ADDENDUM NO. 1

**TRI-COUNTY SCHOOL JR-SR HIGH SCHOOL BACKPACK ADDITION &
NEW MAINTENANCE FACILITY
Wolcott, IN 47995**

ADDENDUM ONE

Addendum One (AD.01) to the drawings and specifications prepared by Gibraltar Design for **Tri-County Jr/Sr High School Backpack Addition & New Maintenance Facility** for Tri-County School Corporation, Wolcott, Indiana.

2. Sheet C-102

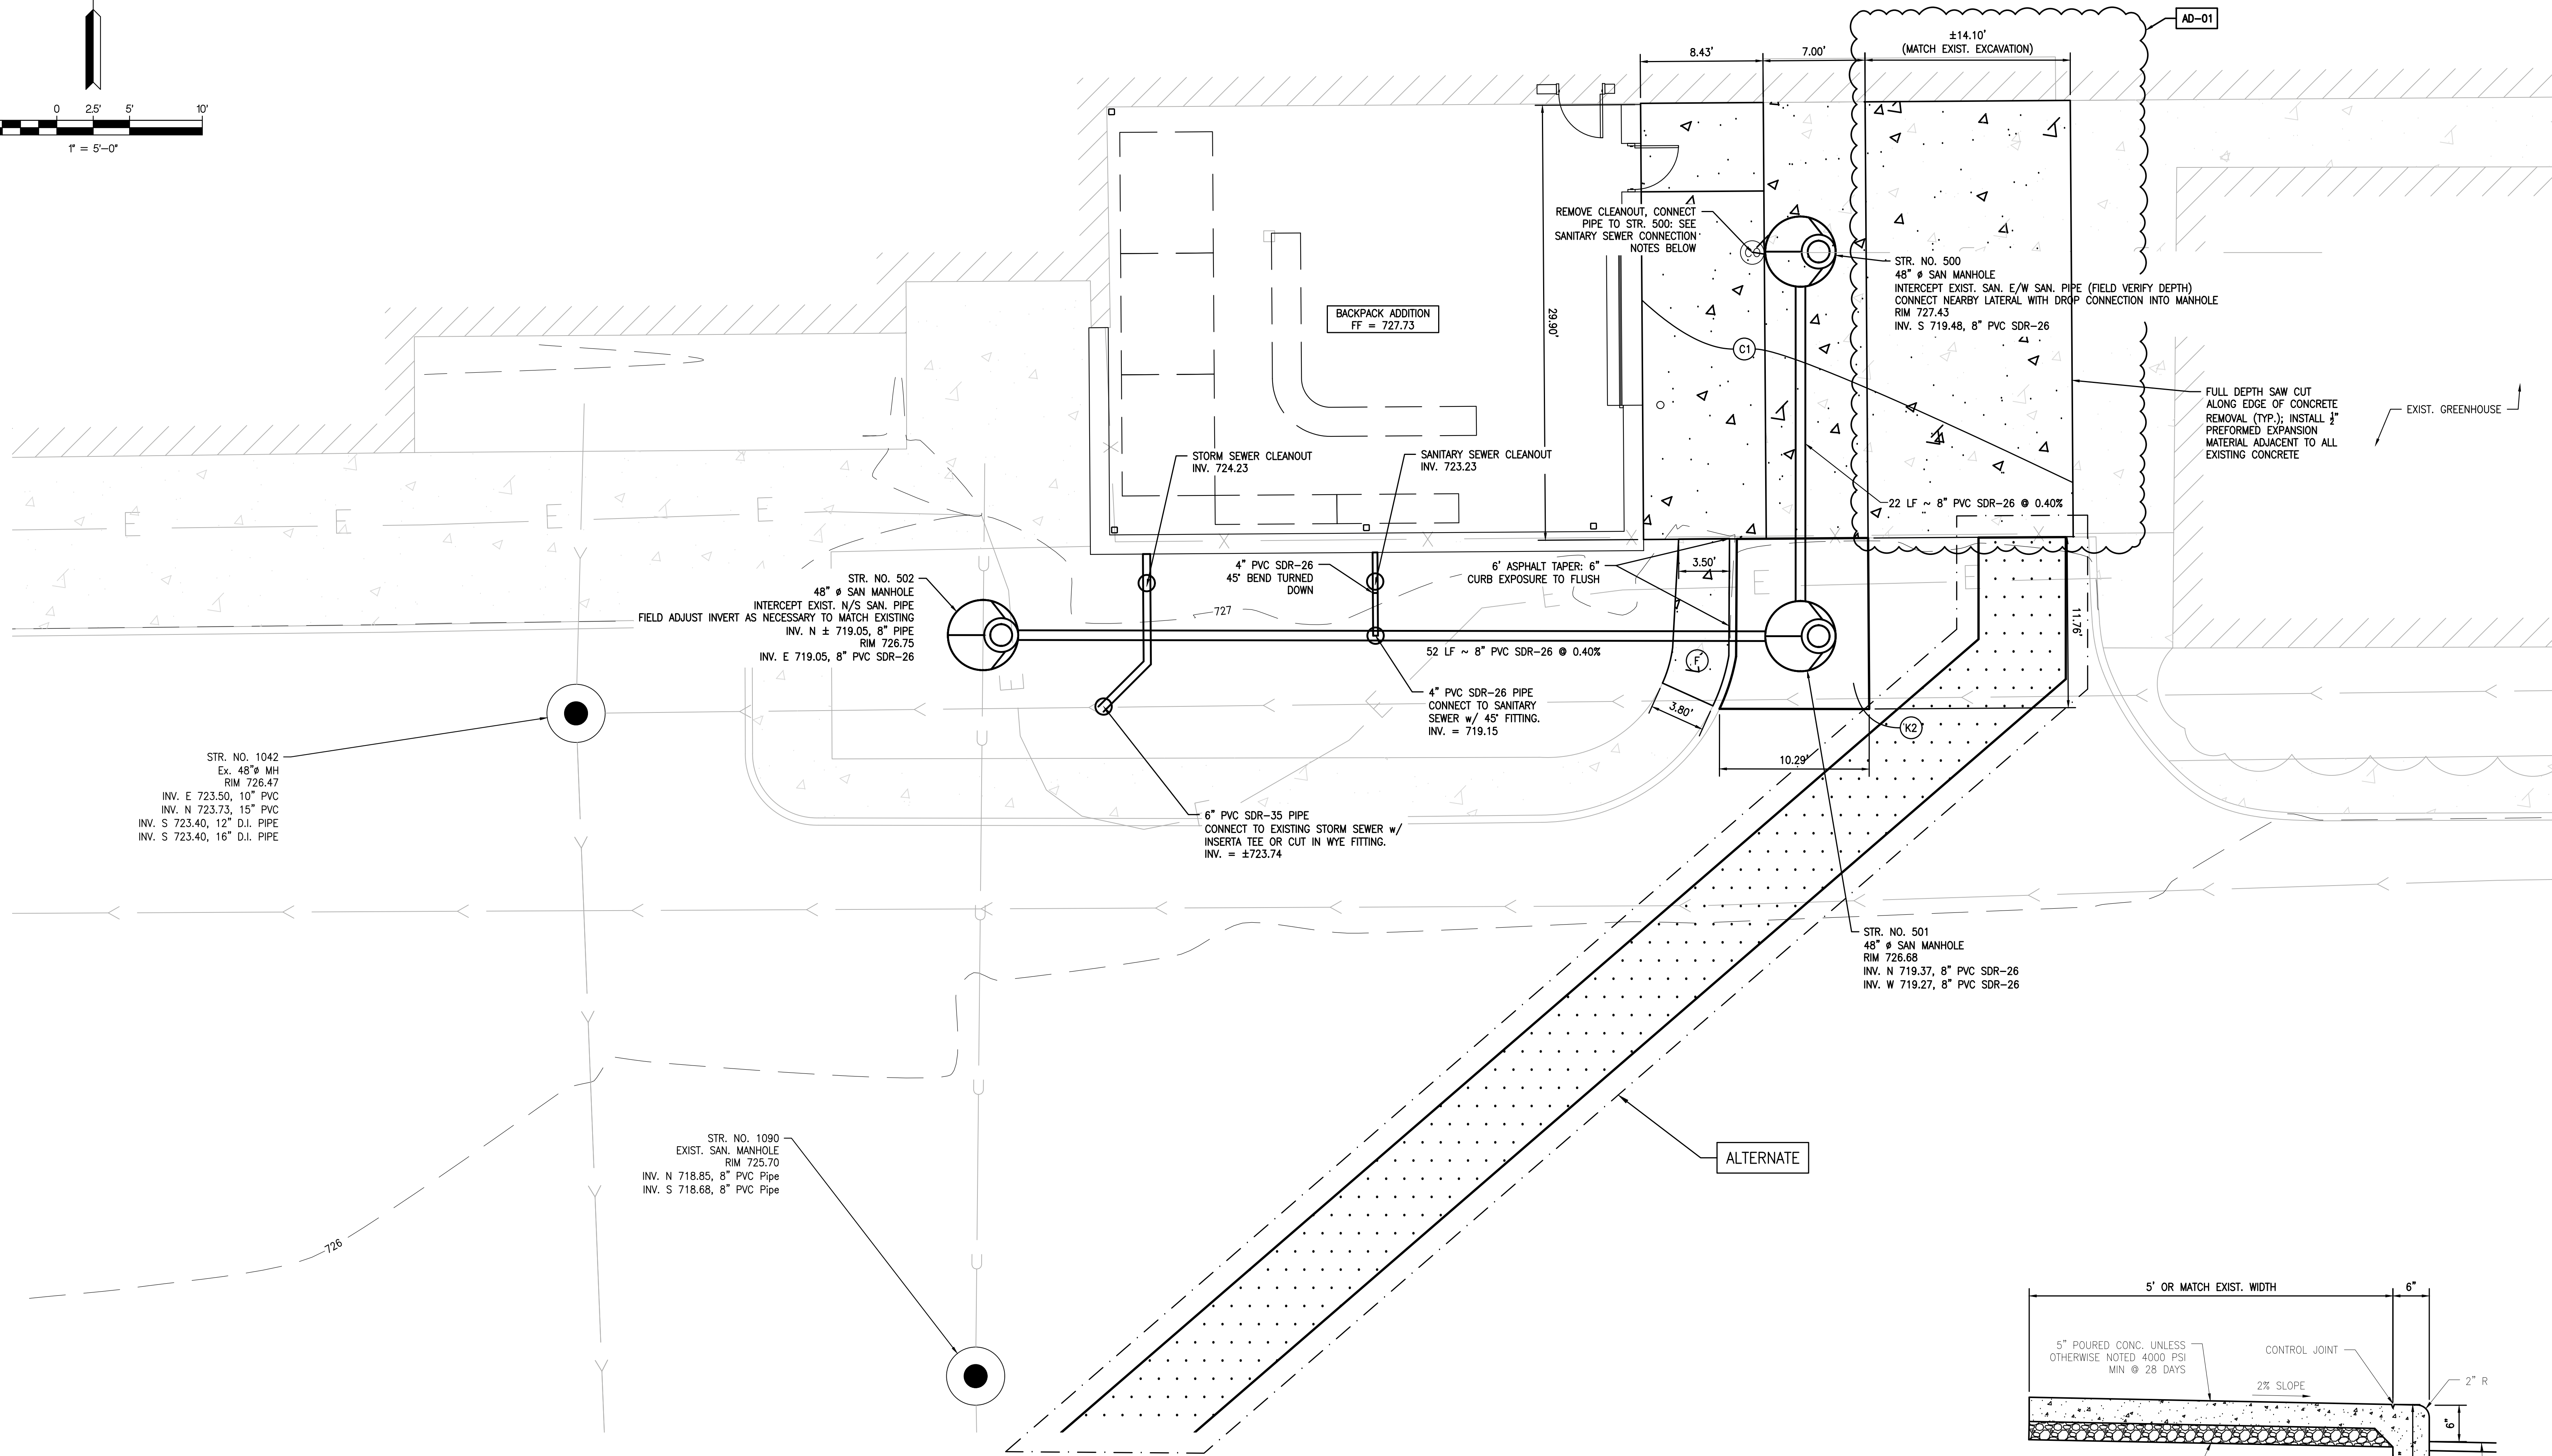
- A. Revised concrete replacement limits.

ADDENDUM 1 REVISIONS:
1. REVISED CONCRETE REPLACEMENT LIMITS.

3. Sheet C-103

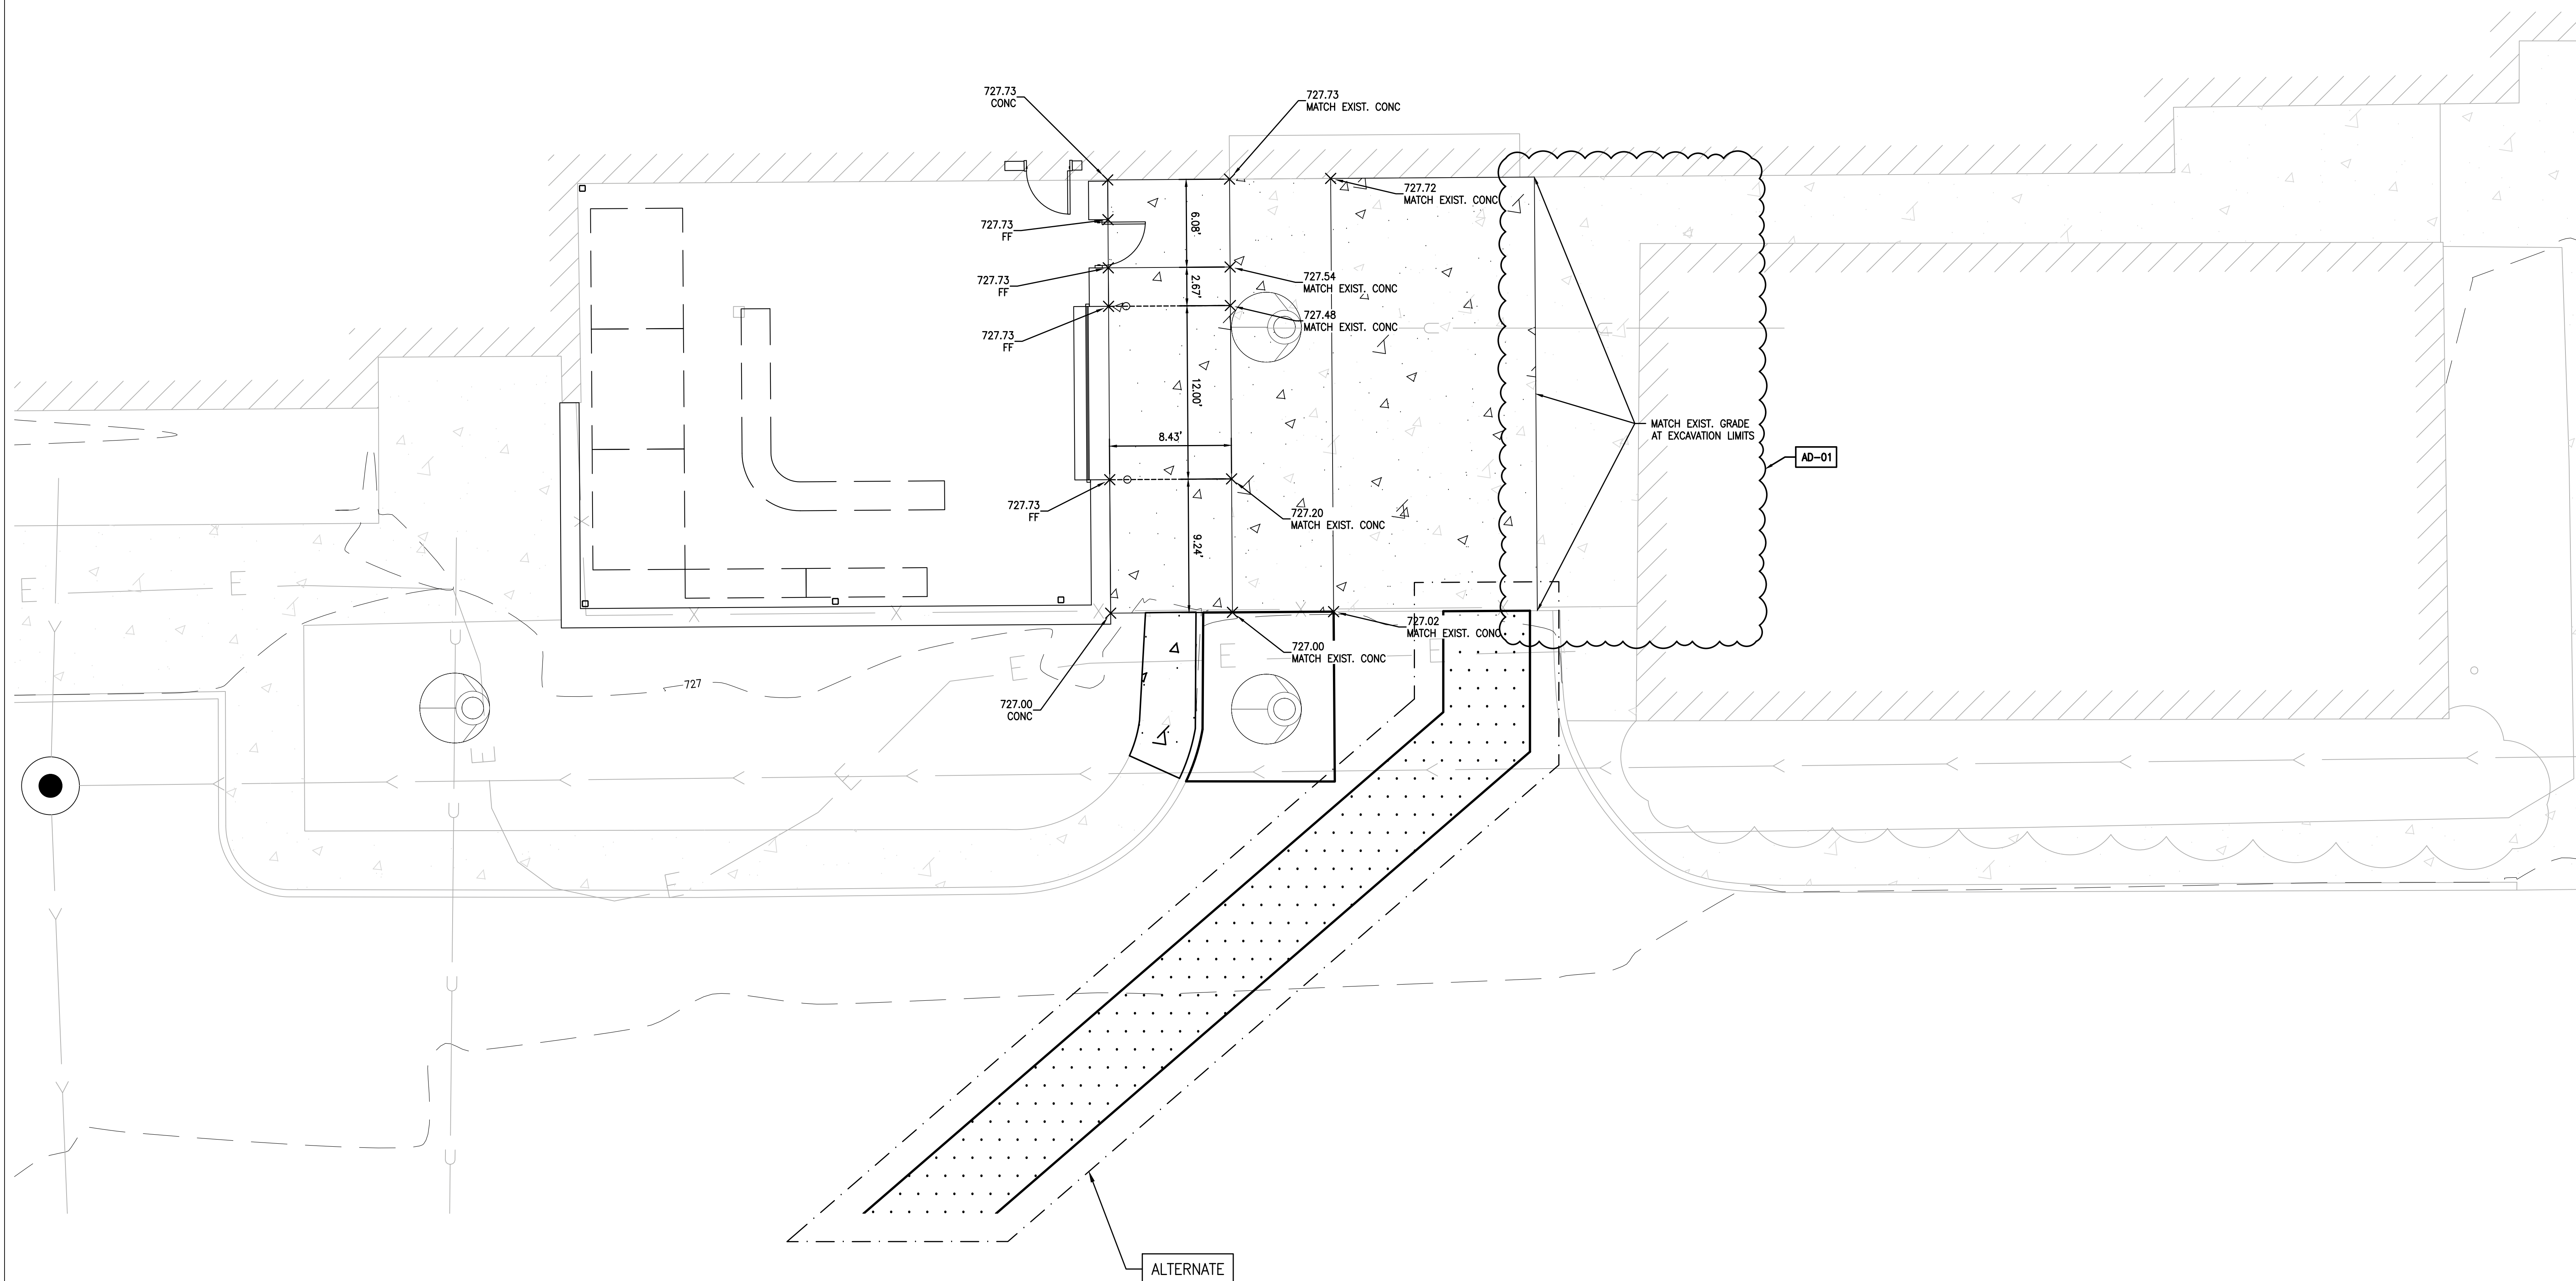
- A. Revised concrete replacement limits and added additional grading callout.

ADDENDUM 1 REVISIONS:
1. REVISED CONCRETE REPLACEMENT LIMITS AND ADDED ADDITIONAL GRADING CALLOUT
